2 REQ'D ~ Mk. M21A

1	04/05/12	PG	BOLTS REVISED TO A325 BLACK LEGEND UP DATED ISSUED FOR FINAL APPROVAL
B	03/15/12	RC	NOTES UPDATED AND BOLTS REVISED TO A325 GALV FOR APPROVAL
A	03/02/12	RC	FOR APPROVAL
NO.	DATE	BY	REVISION
STS STEEL, INC. ENGINEERS • FABRICATORS • ERECTORS PH: (518) 370-2693 FAX: (518) 370-2696			
DRAWING TITLE			
UPPER STEEL (END PORTAL TS3)			
PROJECT No. US RT 2 BRIDGE No 24 FEDERAL AID No.			
ENGINEER : CHA			
CUSTOMER : Harrison & Burrows Bridge Constructors, Inc.			
PROJECT : RICHMOND, VT - TRUSS BRIDGE REHAB			
RICHMOND, VT			
HOLS:	15/16" U.N.O.	PAINT:	PER SPEC
BOLTS:	A325 U.N.O.	DR.BY:	RC
WELDS:	AWS D1.5	CHK.BY:	BH
DATE:	03/01/12	JOB NO.:	1156
		OWG NO.:	21

DETAIL 1

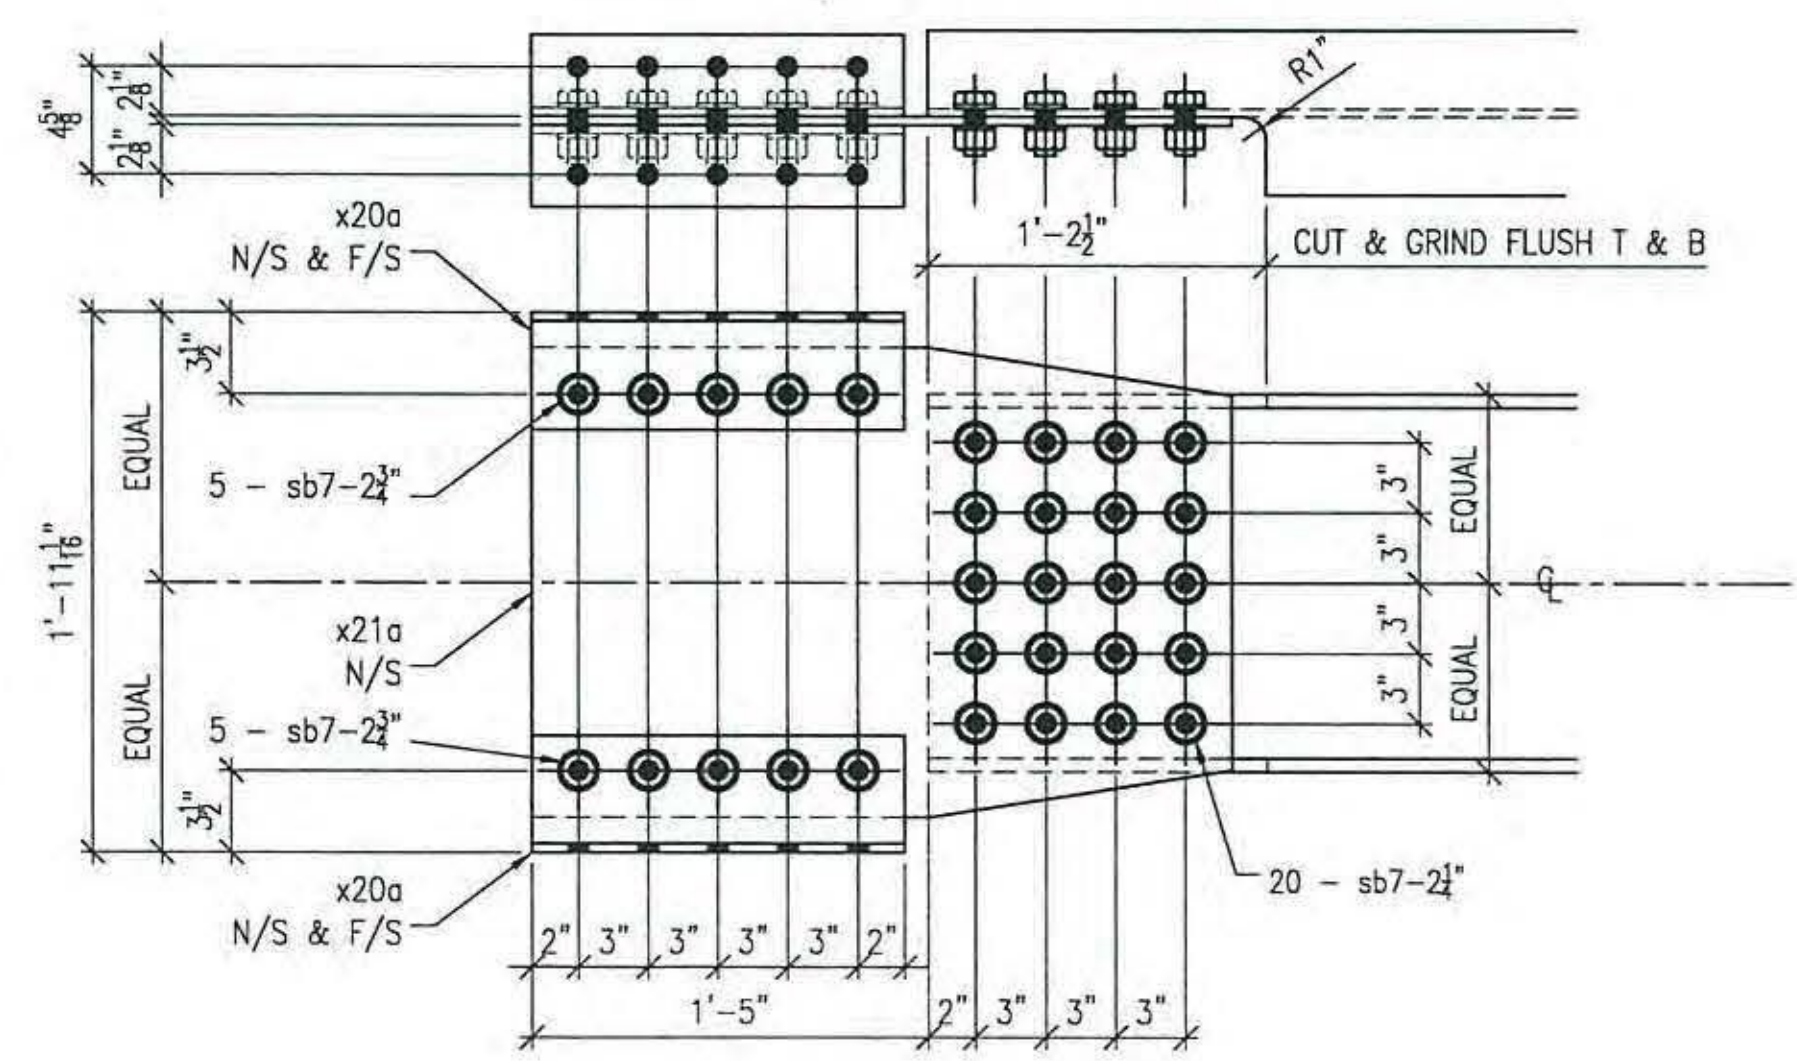
OVER ALL DEPTH OF TRUSS
1'-11 1/16" THE ORIGINAL DETAILS
HAD 1/8" OF ERECTION CLEARANCE
AT TS1 & TS2
